Project	IEEE 802.16 Broadband Wireless Access Working Group < <a href="http://ieee802.org/16">http://ieee802.org/16</a> >
Title	RS Initial Ranging for Network Entry
Date	2007-04-25
Submitted	
Source(s)	Kanchei (Ken) Loa, Yi-Hsueh Tsai, Voice: +886-2-2739-9616 Chih-Chiang Hsieh, Yung-Ting Lee, Fax: +886-2-2378-2328 Hua-Chiang Yin, Shiann-Tsong Sheu, <a href="mailto:loa@nmi.iii.org.tw">loa@nmi.iii.org.tw</a> Frank C.D. Tsai, Youn-Tai Lee, Heng-Iang Hsu Institute for Information Industry 8F., No. 218, Sec. 2, Dunhua S. Rd., Taipei City, Taiwan.
	[add other co-author here]
Re:	IEEE 802.16j-07/013: "Call for Technical Comments Regarding IEEE Project 802.16j"
Abstract	This contribution proposes RS Initial Ranging for Network Entry
Purpose	Adopt the text proposal in this document
Notice	This document has been prepared to assist IEEE 802.16. It is offered as a basis for discussion and is not binding on the contributing individual(s) or organization(s). The material in this document is subject to change in form and content after further study. The contributor(s) reserve(s) the right to add, amend or withdraw material contained herein.

# RS Initial Ranging for Network Entry

Figure 1 Comparison between Original and Proposed Ranging Code Sets

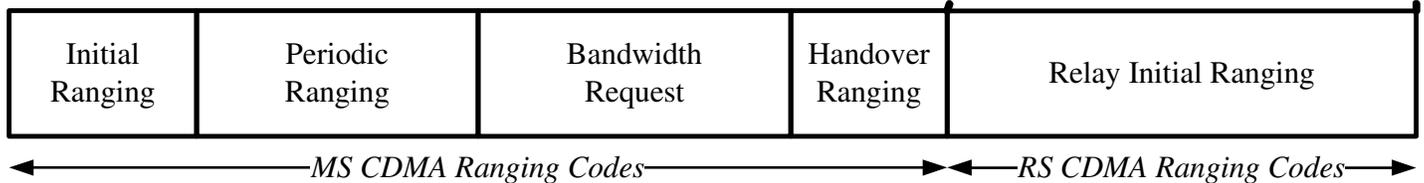
Optional RS Initial ranging codes set, illustrated in Figure 1, is defined for RS initial ranging functionalities. MR-BS should be able to differentiate RS and MS by ranging codes. In order to avoid RS network entry loop due to try and error approaches, MR-BS may abort a RS initial ranging process by sending a RNG-RSP containing status = 2 (abort) with preamble indexes of candidate neighbor access stations. Upon receiving RNG-RSP containing status abort with preamble indexes, RS shall scan for DL channel of candidate neighbor access stations and perform initial ranging again.

- The first  $N$  codes produced are for initial-ranging. Clock the PRBS generator  $144 \times (S \bmod 256)$  times to  $144 \times ((S + N) \bmod 256) - 1$  times.

- The next  $M$  codes produced are for periodic-ranging. Clock the PRBS generator  $144 \times ((N + S) \bmod 256)$  times to  $144 \times ((N + M + S) \bmod 256) - 1$  times.

- The next  $L$  codes produced are for bandwidth-requests. Clock the PRBS generator  $144 \times ((N + M + S) \bmod 256)$  times to  $144 \times ((N + M + L + S) \bmod 256) - 1$  times.

- The next  $O$  codes produced are for handover-ranging. Clock the PRBS generator  $144 \times ((N + M + L + S) \bmod 256)$  times to  $144 \times ((N + M + L + O + S) \bmod 256) - 1$  times.

- The next  $P$  codes produced are for RS initial-ranging. Clock the PRBS generator  $144 \times ((N + M + L + O + S) \bmod 256)$  times to  $144 \times ((P + N + M + L + O + S) \bmod 256) - 1$  times
